City of Rochester

PLANNING COMMISSON REGULAR MEETING AGENDA

400 Sixth Street	September 8, 2026	7:00 PM
-------------------------	--------------------------	----------------

Subject: **118 W. Third Street; Special Project and Site Plan Review;** Site Plan and Project Narrative received August 18, 2026.

NORTH ELEVATION

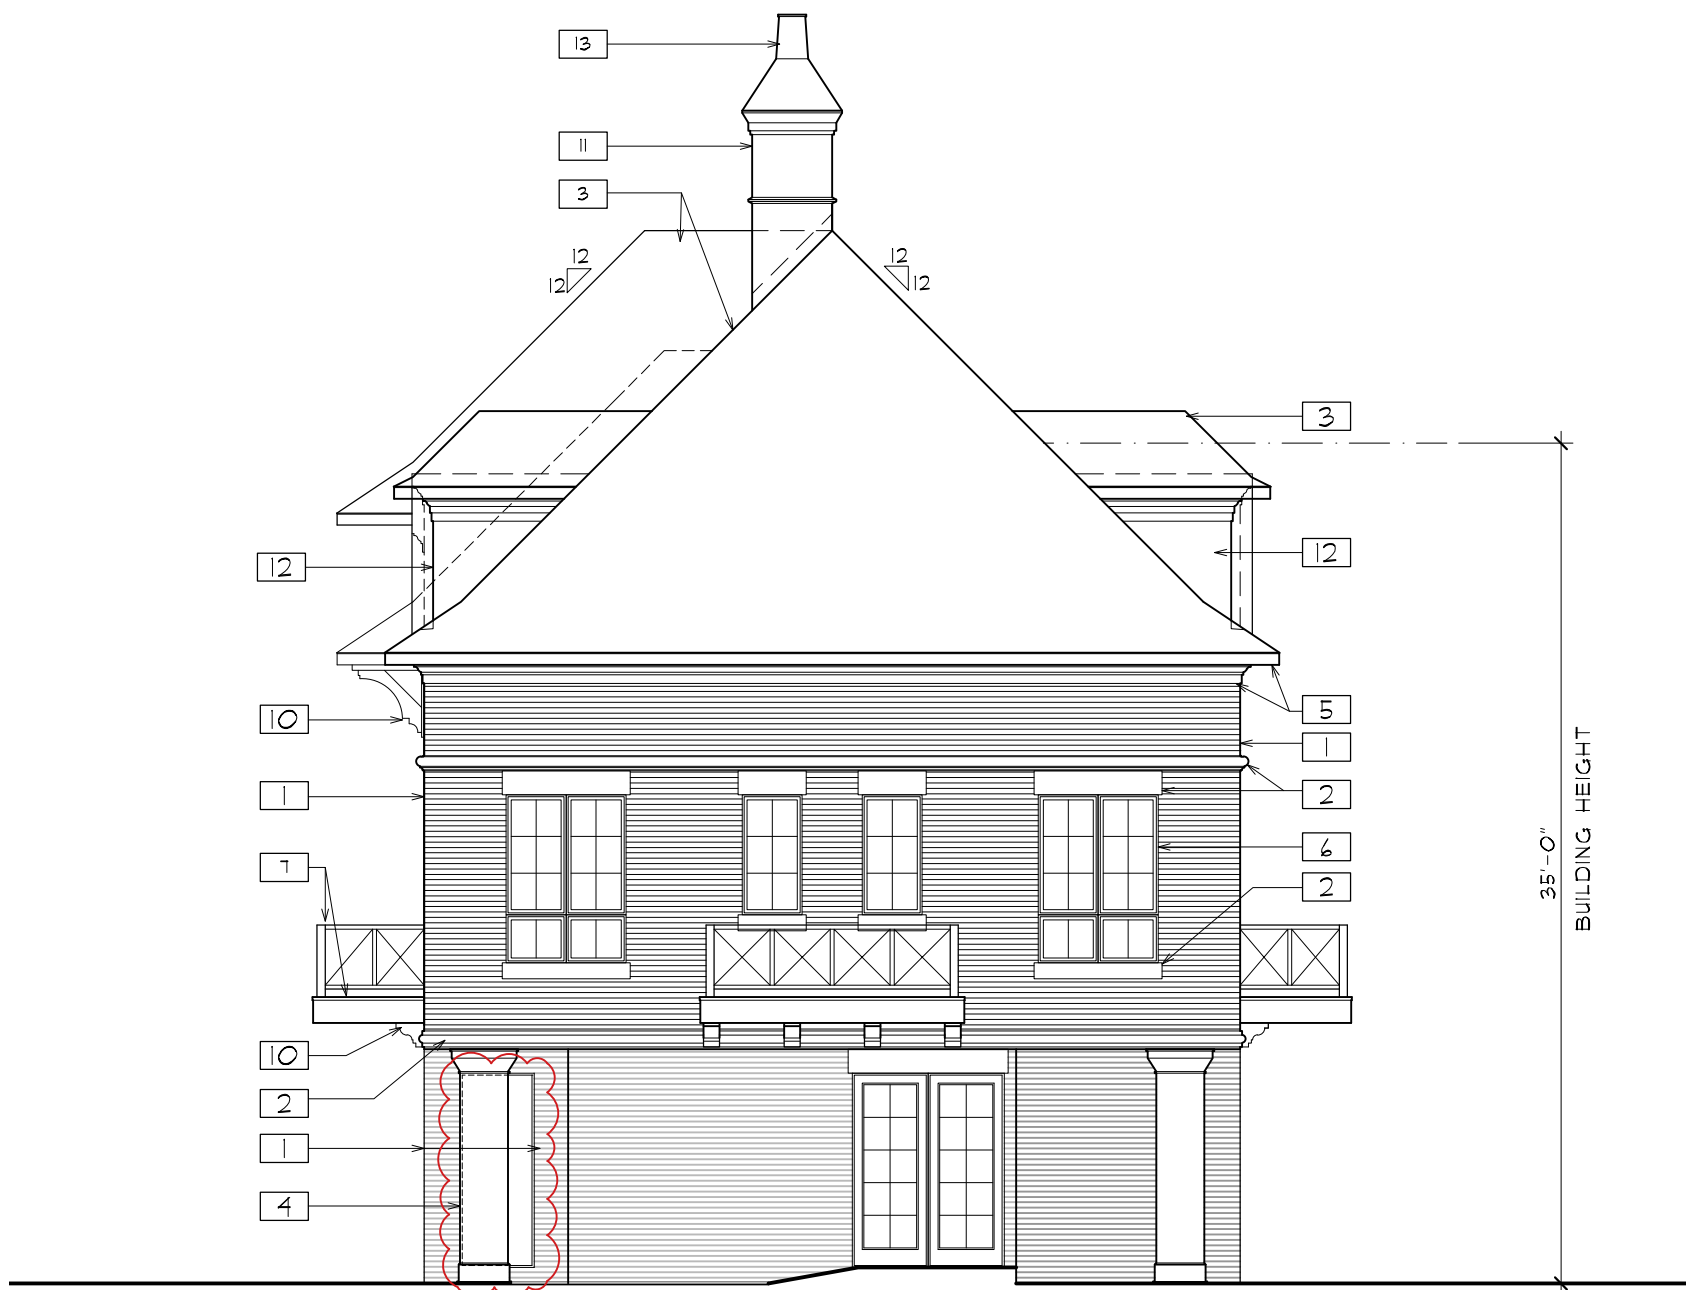
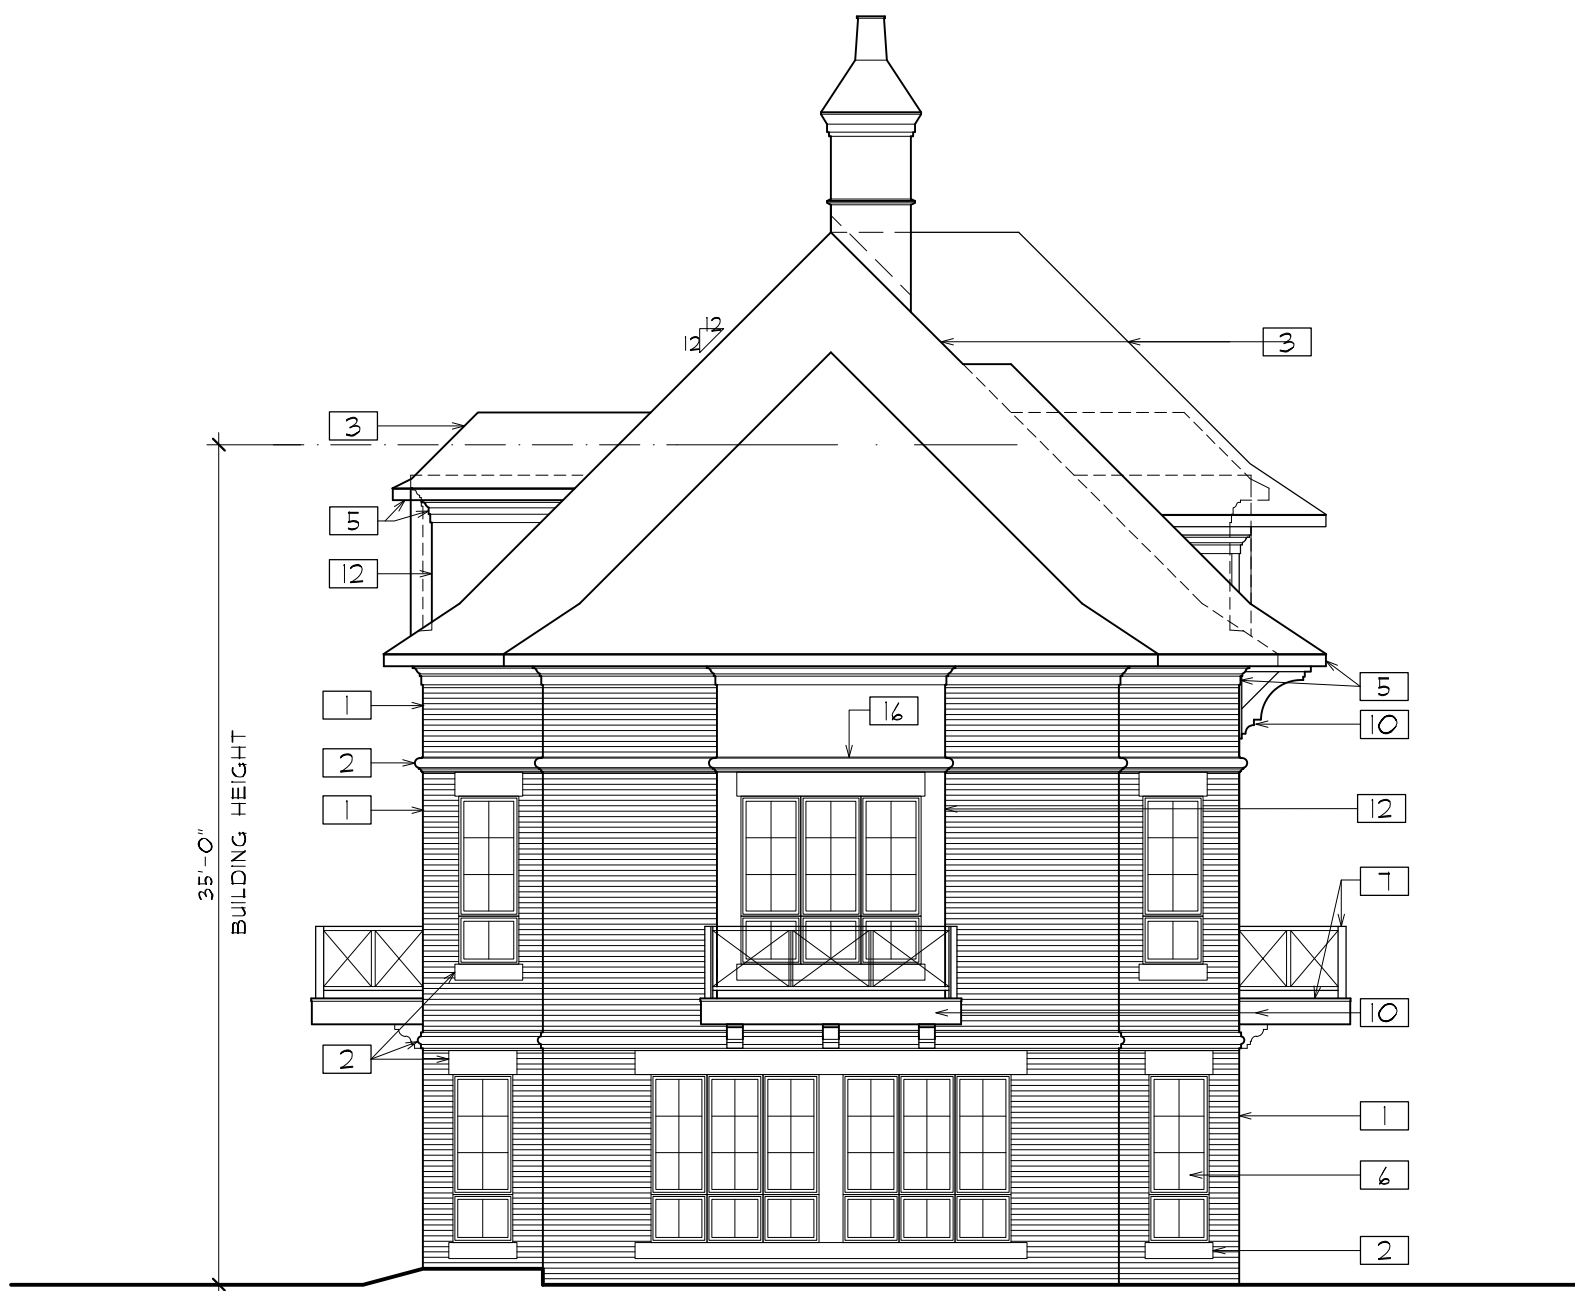
The addition of windows on the north elevation and a new entrance on the east elevation is compatible with the previously approved design and does not substantially alter the appearance of the building. Therefore, we recommend that the Planning Commission place the above-mentioned plan on the next available agenda for public hearing and consideration of site plan approval.

ARCHITECTURAL SITE PLAN

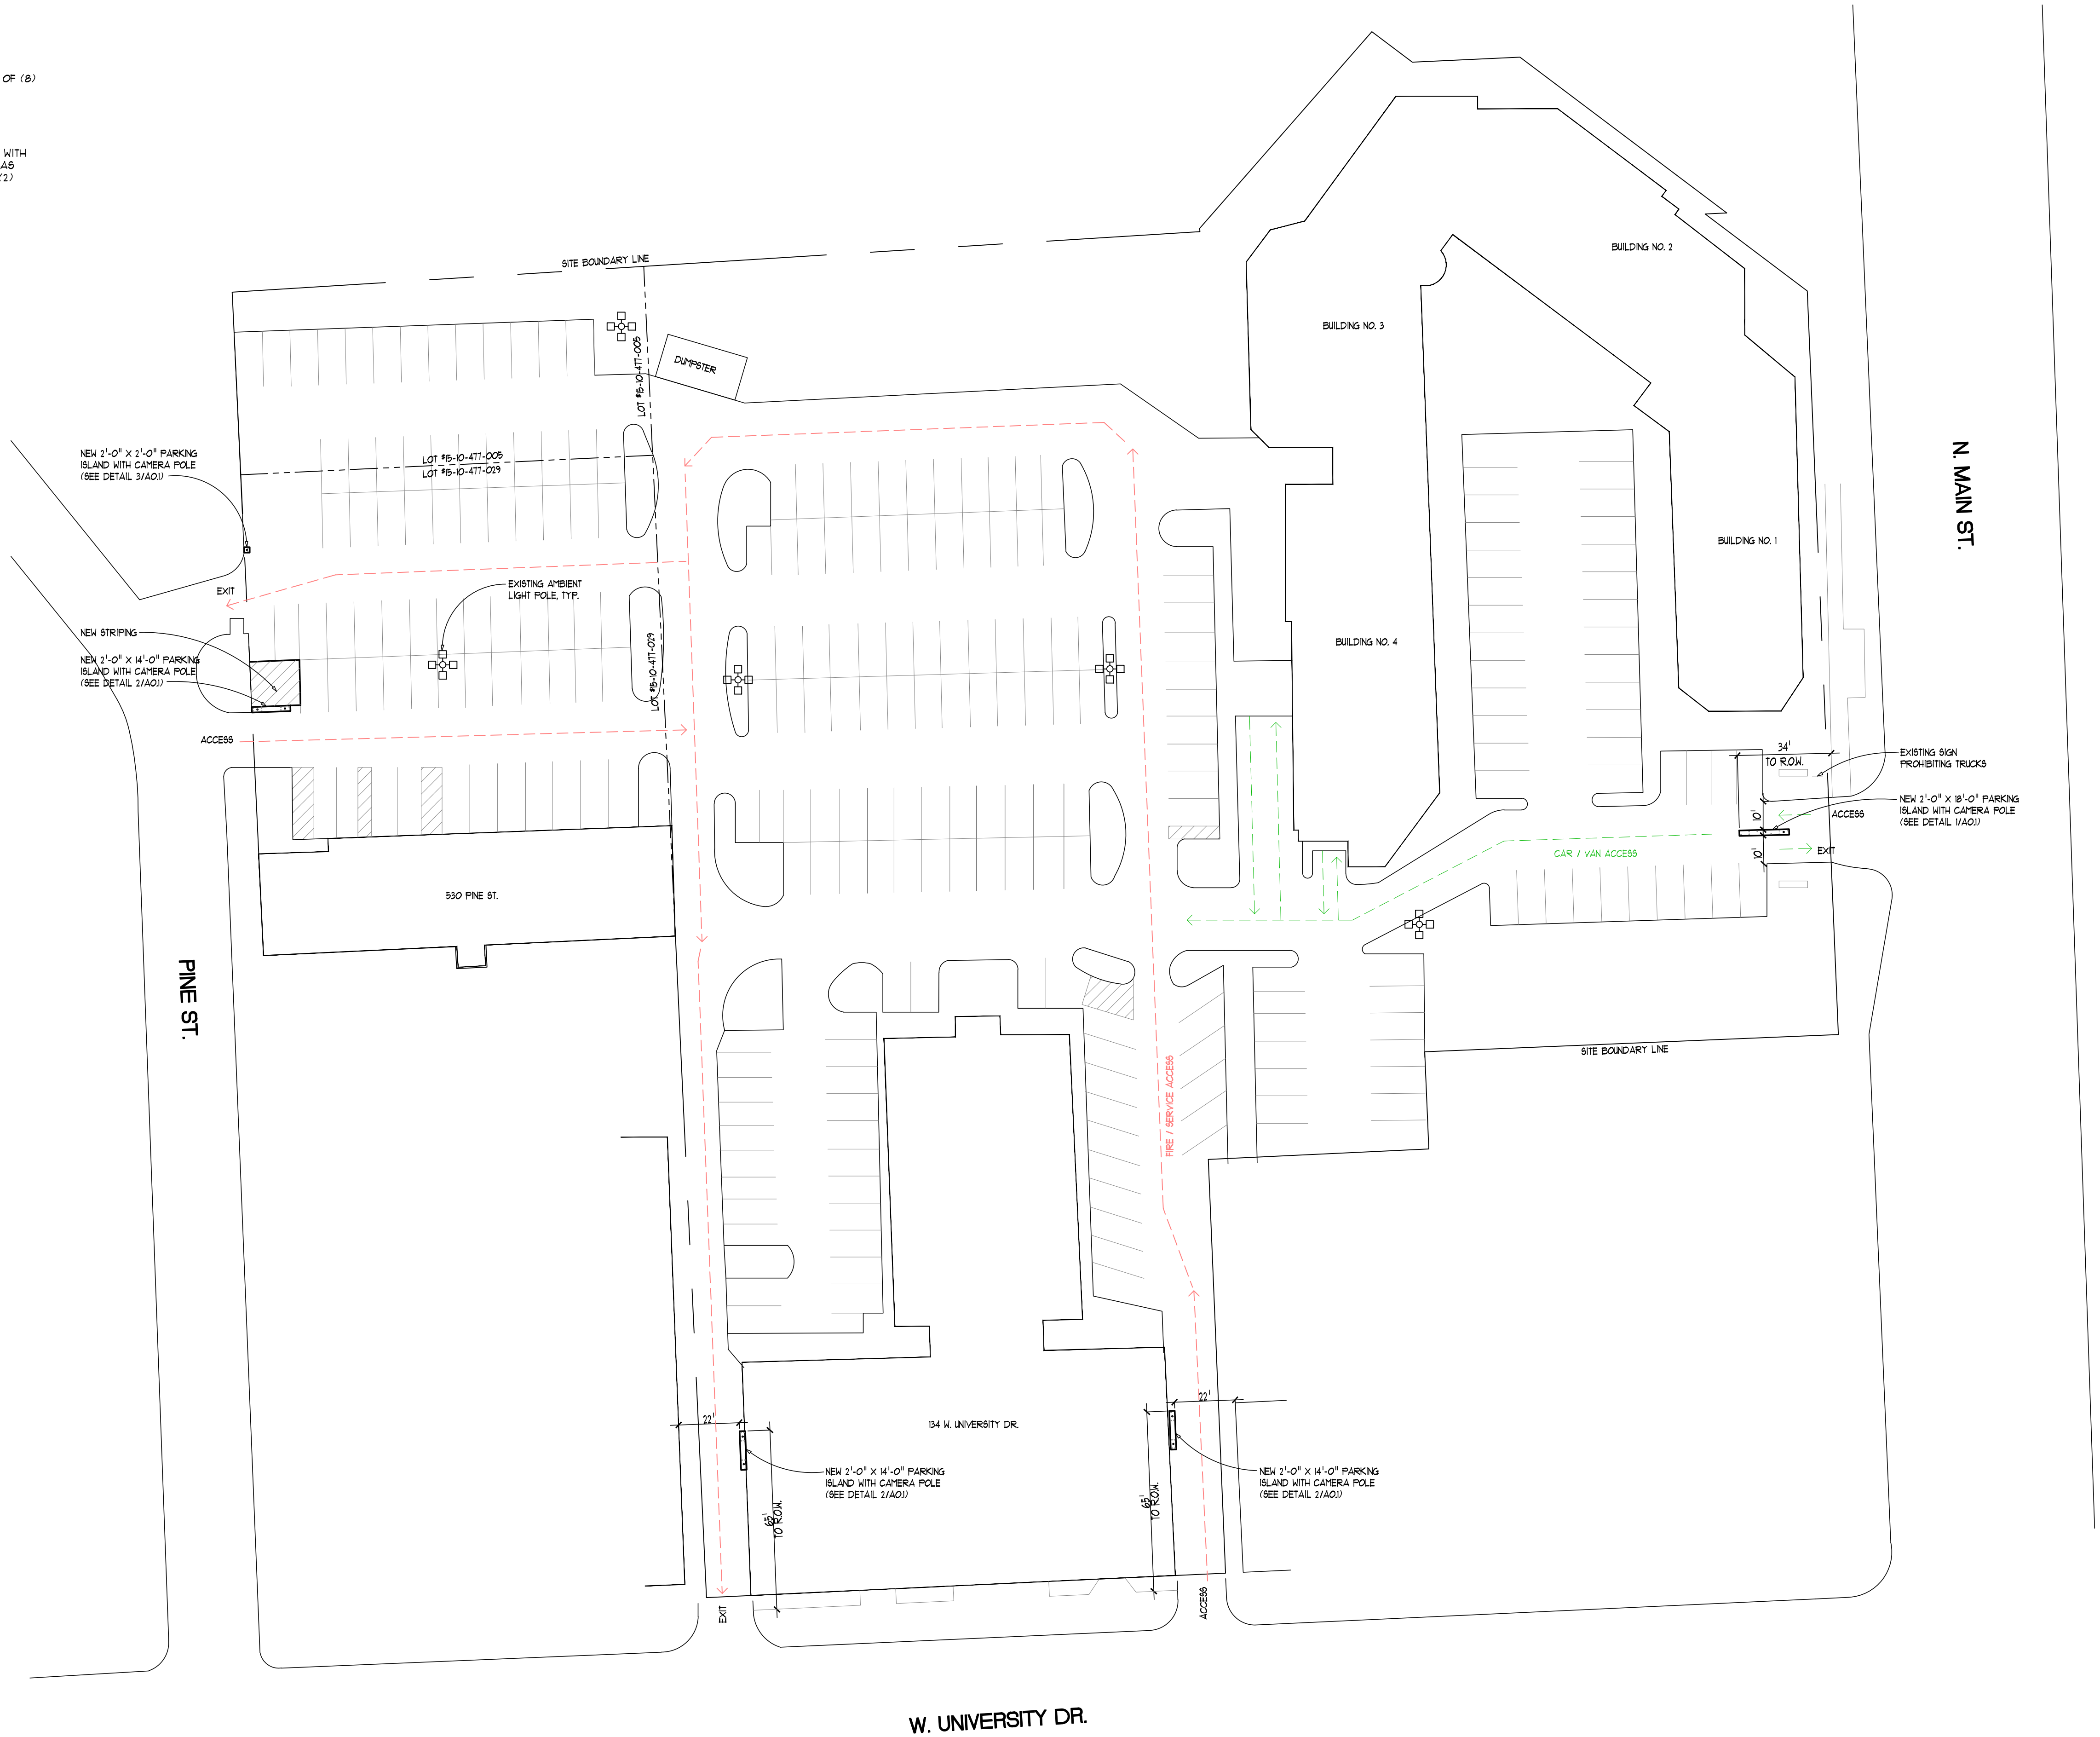
While the proposed improvements to 530 Pine Street do not inherently fail to comply with the Zoning Ordinance, one of the key purposes of zoning is the maintenance of public health and safety. Therefore, it is recommended that site approval be granted, contingent on compliance with the requirements of the Fire Department, as included in the review letter and listed below: Remove the concrete entrance island located at the N. Main Street entrance to Rochester River Square, 530 Pine Street, in its entirety.

- Remove all bollards associated with the concrete island configuration at the Main Street entrance throat.
- Restore the entrance lane width to a minimum unobstructed width of 20 feet in compliance with IFC Section 503.2.1.
- Provide written confirmation of compliance to the Fire Chief upon completion of the removal.
